CITY PLAN COMMISSION STAFF REPORT

Indiana Commons at Staley Corners East

CD-CPC-2024-00142
Rezoning without Plan

CD-CPC-2024-00143
Non-Residential Development Plan

C-1

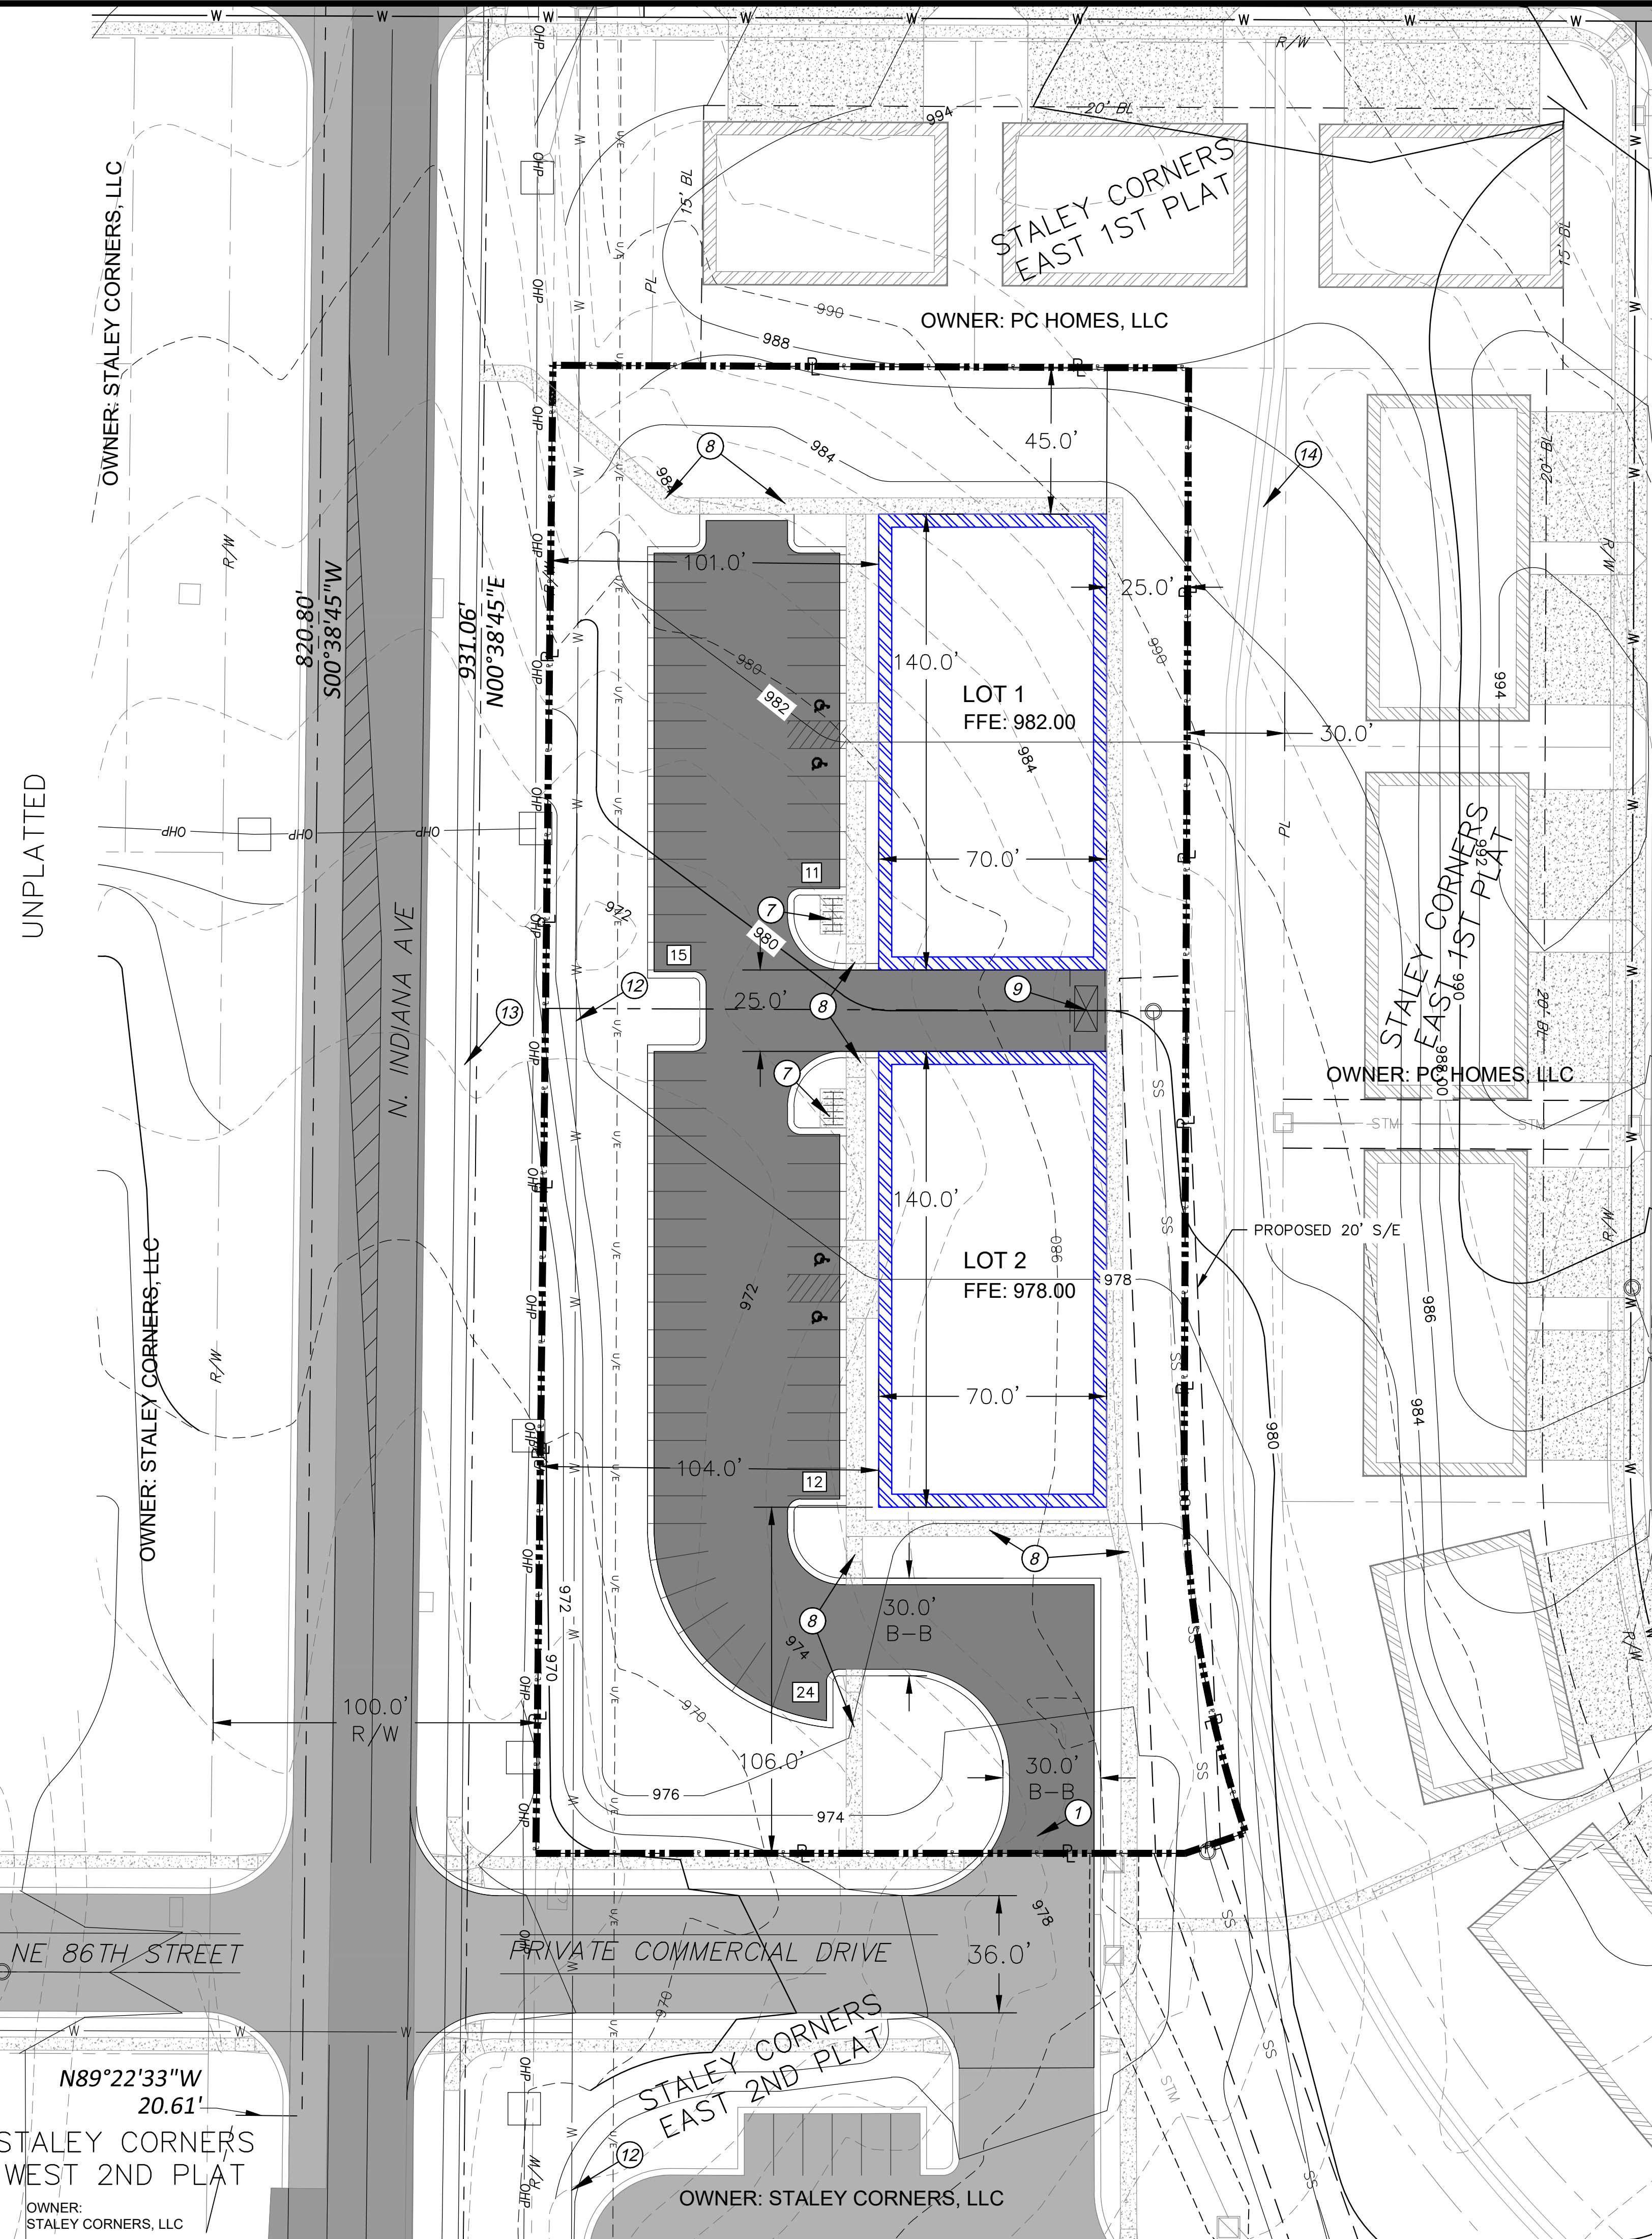
The original plan showed the senior housing adjacent to N. Indiana Avenue, screening the parking spaces from the public right-of-way. The applicant plans to construct 62 parking stalls adjacent to N. Indiana Avenue,

screened with a variety of ornamental trees, shrubs and grasses. Two pedestrian connections are proposed from both the southern and northern edges of the vehicular use area to the sidewalk along N. Indiana Avenue.

Staff worked with the applicant to enhance the proposed vehicular use area that will be visible from N. Indiana Avenue. There are currently multiple town homes being constructed immediately east of the proposed retail buildings and staff believe the two structures can serve as a buffer for future residents. The applicant also enhanced the architectural materials and overall design of the proposed structures to provide more four-sided architecture since the rear of the building will be visible from the residential units. There is an internal walking trail that runs along the rear (east side) of the proposed commercial structures which will be screened with additional landscaping to provide a more pleasant pedestrian experience.

8. Prior to ordinance request the applicant shall enter into an agreement with the Director of Public Works to construct a signal at the intersection of NE Barry Road and N. Indiana Avenue.

L1

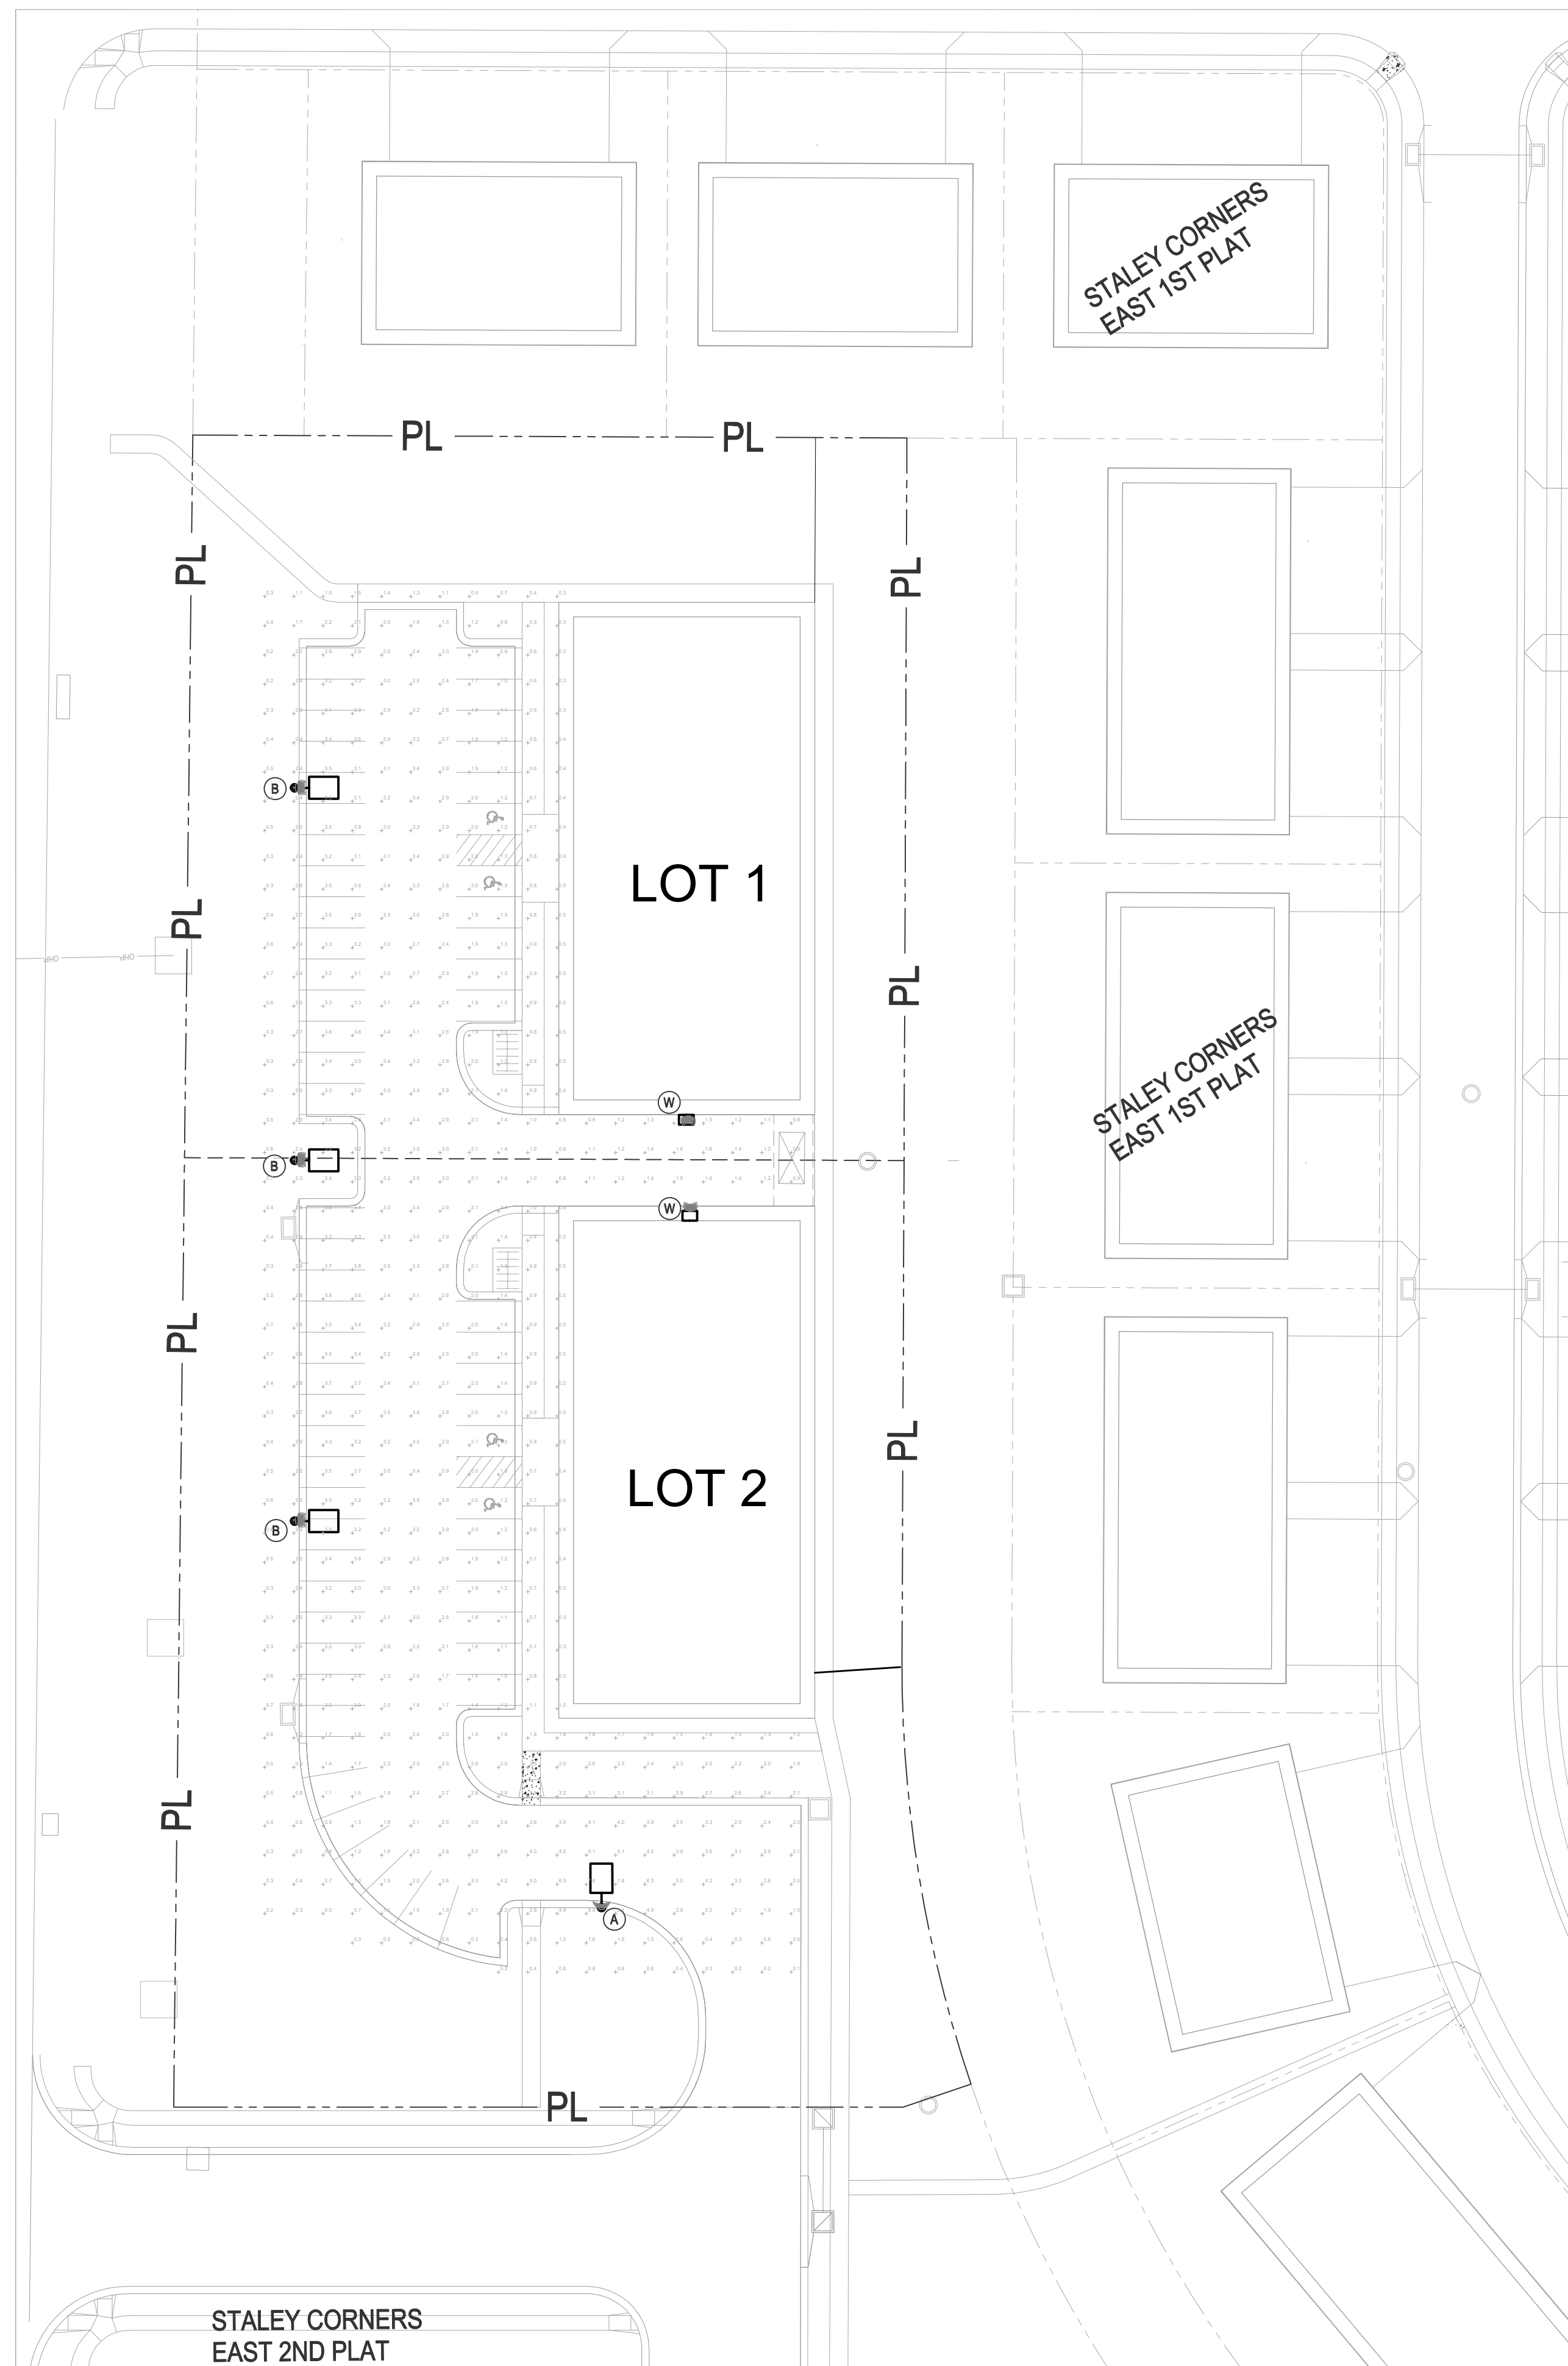
The applicant will provide a variety of plantings along N. Indiana Avenue and along the rear of the proposed buildings. The proposed landscape plan meets the minimum requirements per 88-425 of the Zoning and Development Code.
